Technical Document LA25019

Application under the Agricultural Operation Practices Act for a confined feeding operation, manure collection area, and/or manure storage facility(ies)

NRCB USE ONLY	Application number	Legal land description
<input checked="" type="checkbox"/> Approval <input type="checkbox"/> Registration <input type="checkbox"/> Authorization <input type="checkbox"/> Amendment	<u>LA25019</u>	<u>Sec. 28-10-25 W4M</u>

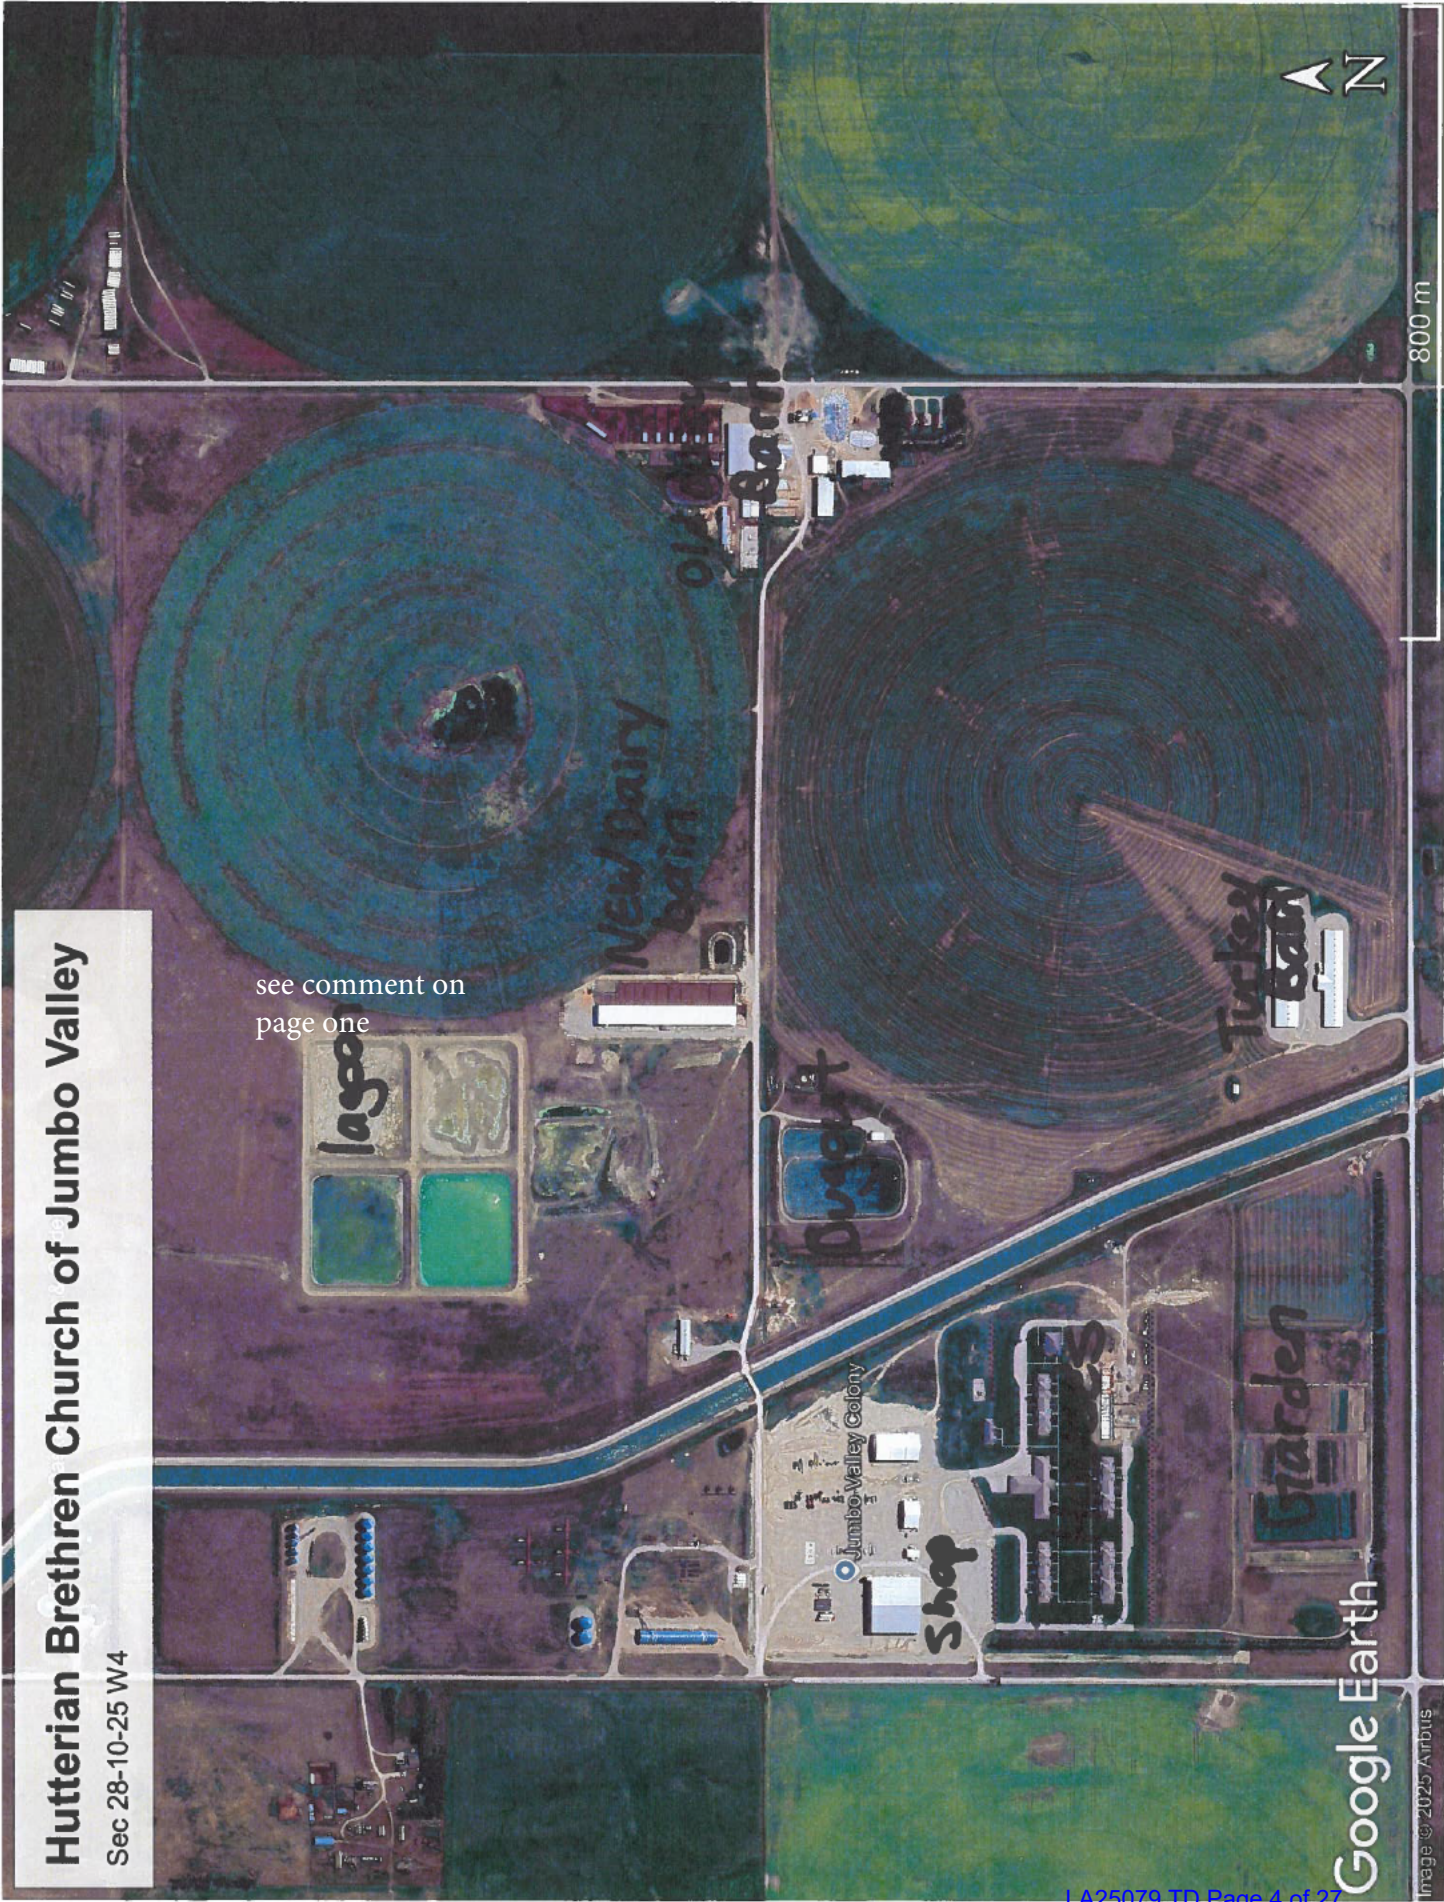
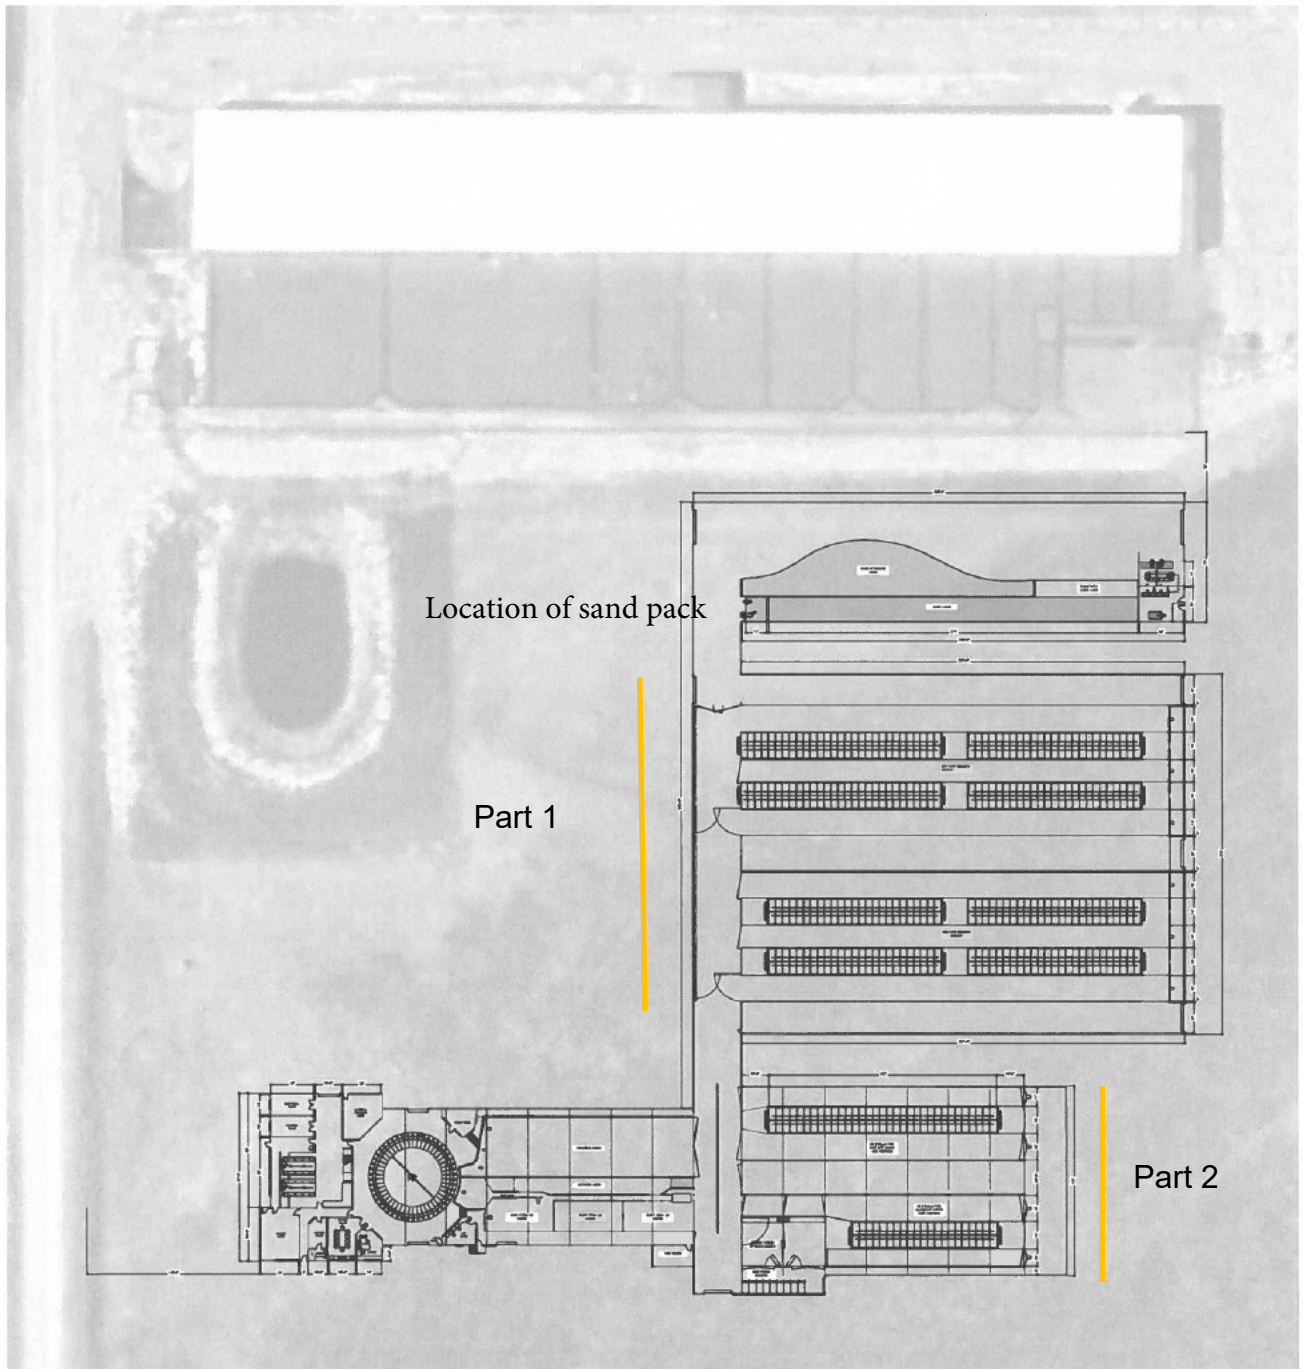
see comment on
page one
